**Subject: Part I (Wetlands & Streams) Joint Permit Application No. 10-1256
Addendum 3, Response to Additional Regulatory Information Requests
Virginia Electric and Power Company (Dominion)
North Anna Power Station - Proposed Unit 3
Louisa County, Virginia**

This Addendum 3 provides responses to the additional information requests from these agencies.

REVISED GRID 13 PLAN VIEW AND CROSS-SECTIONS

Figure 1. GRID 13 – PLAN VIEW

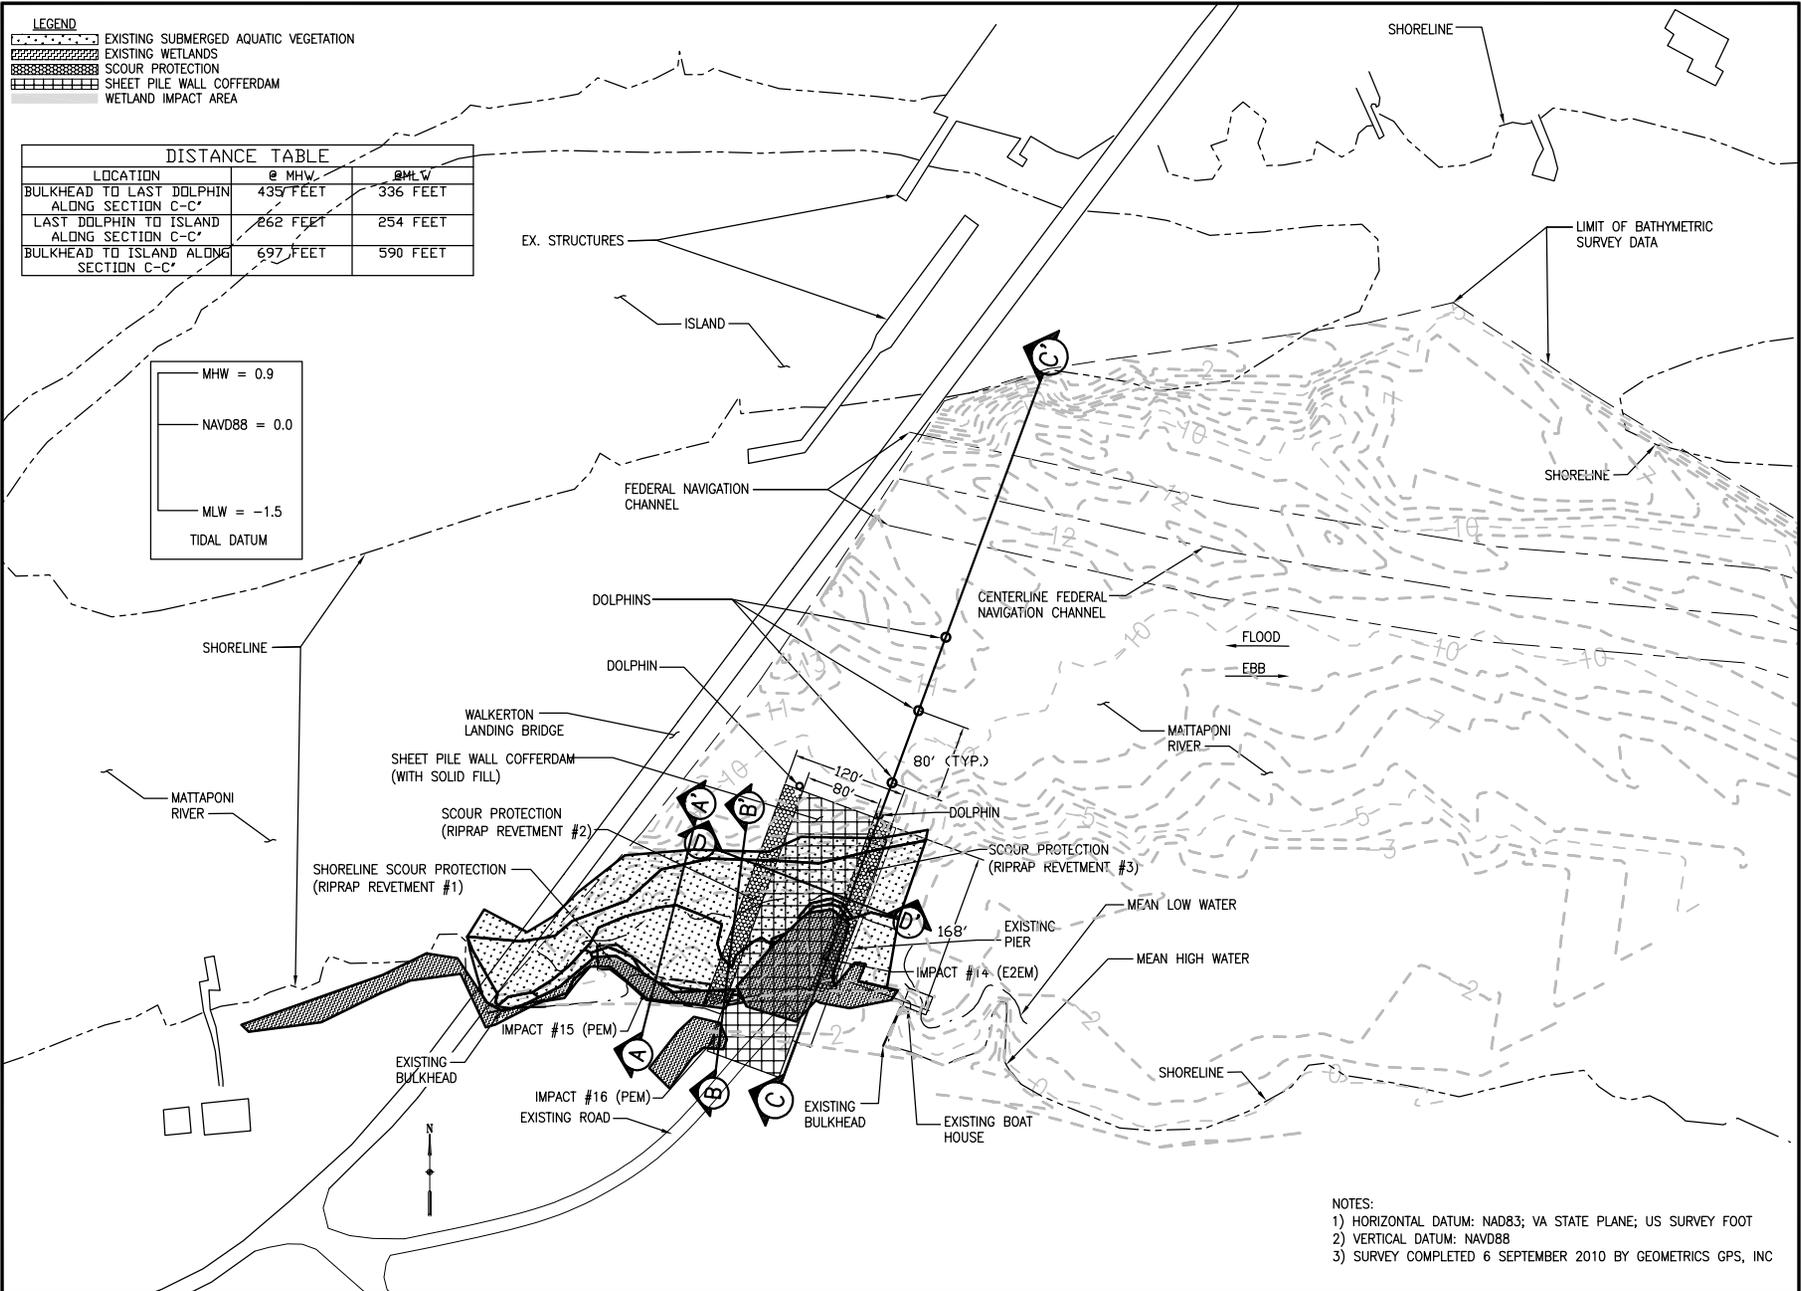
- 2. Three areas are depicted for placement of dolphin/timber piles on the two plan views that depict the Walkerton off-loading site activities (Grid 13 and Figure 1 Grid 13 – Plan View). These three areas are outside the surface water impact limits depicted at this location. DEQ has jurisdiction over activities that occur in surface waters, which include the installation of these piles. Update the impacts table and map to depict these areas as additional impact.**

The impact table and relevant figures have been updated to account for impacts associated with the proposed dolphins. The temporary impacts associated with the dolphins have been calculated and incorporated into Table 6 (see Attachment A). The roll-off facility will include 5 dolphins that will temporarily impact approximately 75 square feet (0.002 acres) of open water. The 5 dolphins include the 3 originally depicted in addition to 2 dolphins to be placed adjacent to the end of the cofferdam. Table 6 also includes the temporary open water impacts associated with the cofferdam and shoreline protection. The cofferdam will temporarily impact approximately 24,312 square feet (0.56 acres) of open water and the shoreline protection will temporarily impact approximately 1,396 square feet (0.03 acres) of open water. The cofferdam, shoreline protection, and dolphins will temporarily impact a total of 25,783 square feet (0.59 acres) of open water. Revised Grid Sheets for the roll-off facility are included in Attachment B.

Figure 5. GRID 13 – CROSS SECTION D – D'

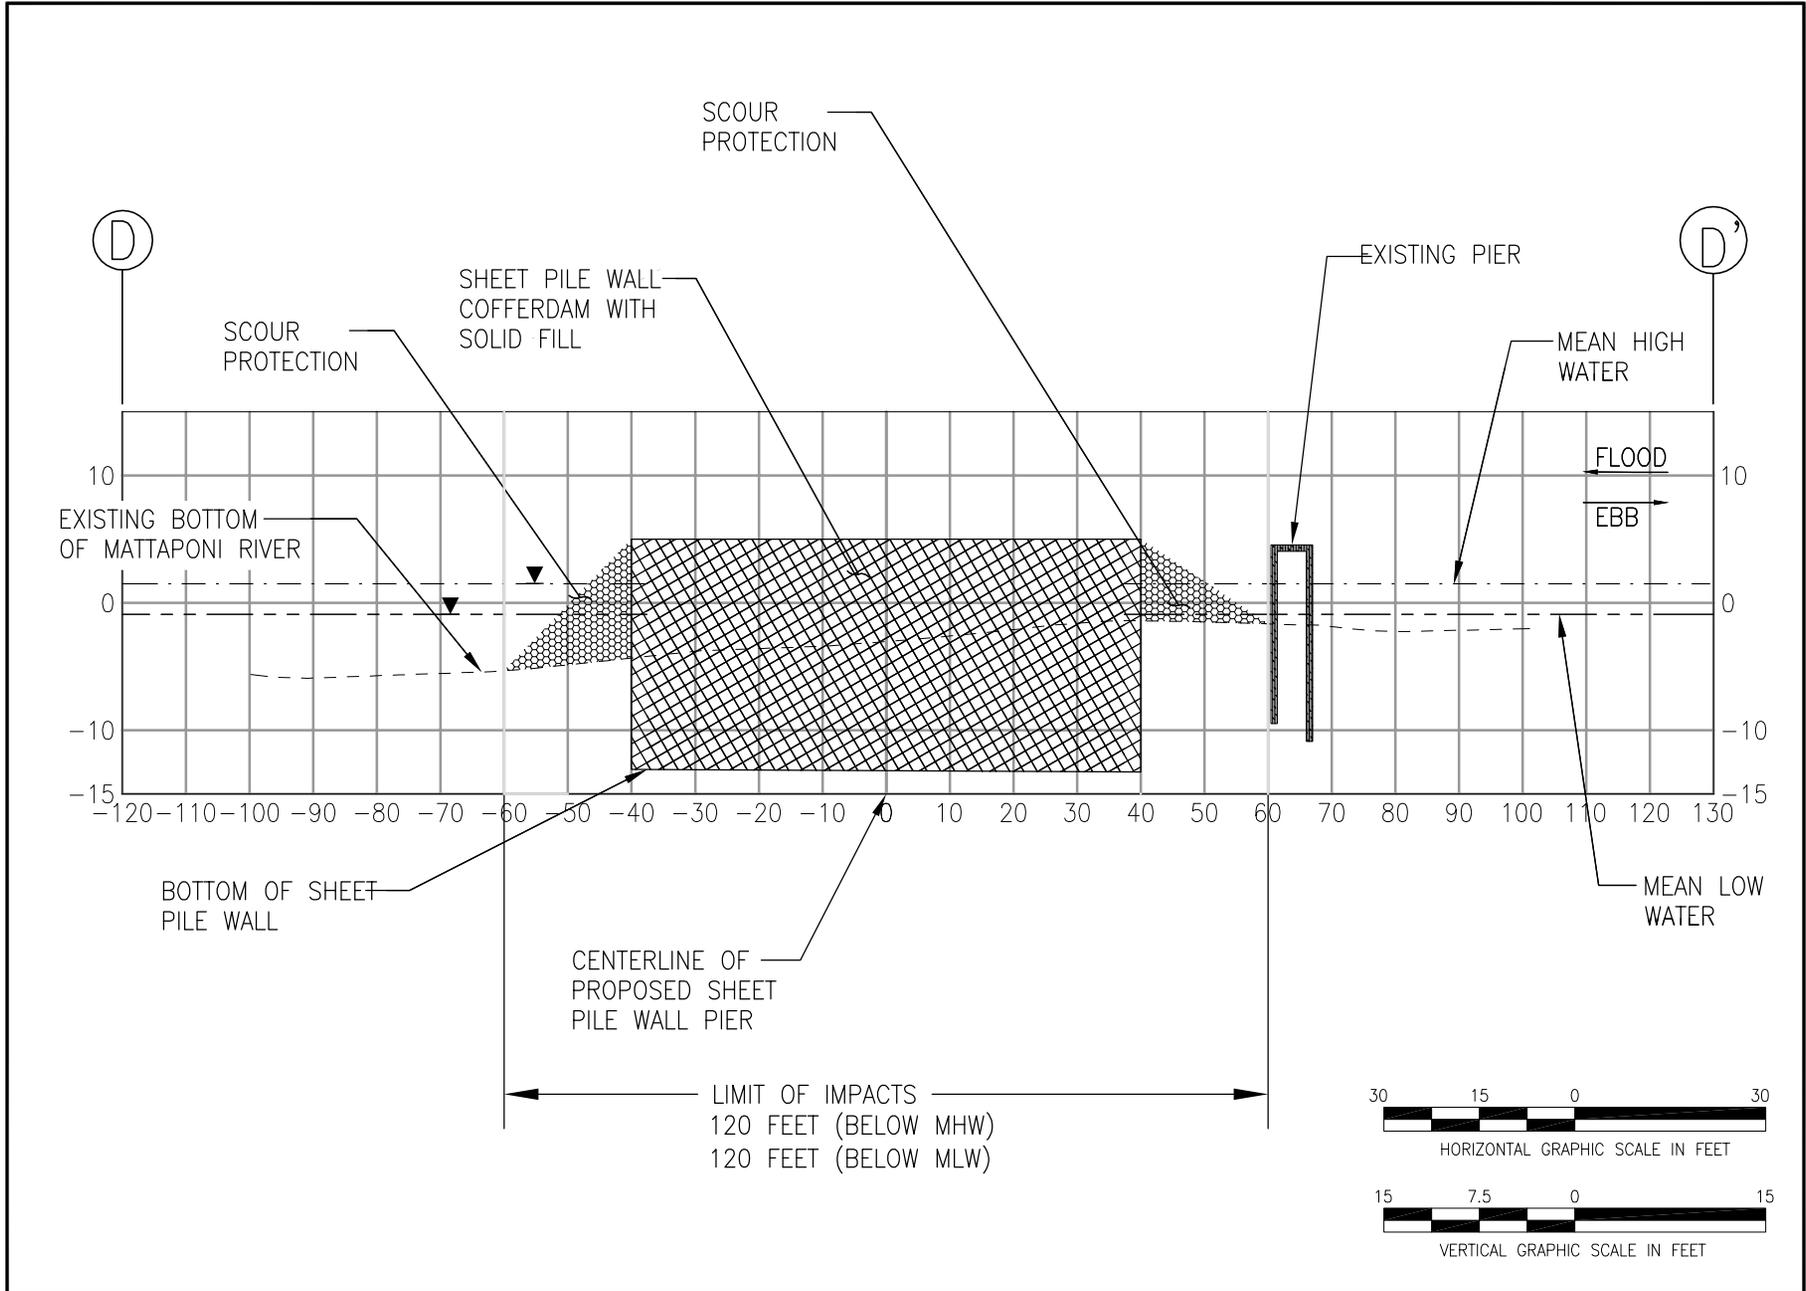
Depict scour protection to the existing bottom of the Mattaponi River on Grid 13 – Cross Section D – D’.

Cross section details depicting the proposed scour protection have been updated to show that rip- rap material will intersect the existing bottom of the Mattaponi River. See Figure 5 Grid 13 – Cross Section D – D’ in Attachment B.
